# SERVICE INFORMATION BULLETIN

**Subject: DESIGN CHANGE OF ENGINE OIL COOLER HOUSING**

This document is to inform dealers of the design change to the engine oil cooler housing for the J05 and J08 engines.

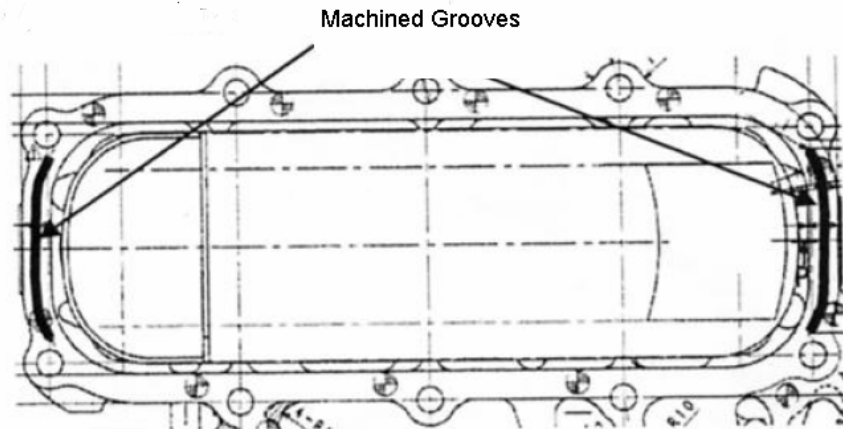
The casting for the engine oil cooler housing has been revised to include 2 shallow machined grooves on both sides of the engine oil cooler housing. These grooves aid in the retention of liquid gasket used during engine production. This changed the appearance of the engine oil cooler housing but does not affect function or applicability.

Engine oil cooler housings with or without the grooves are fully interchangeable. The part numbers have not changed J05 = 157201100A, J08 = 157201400A
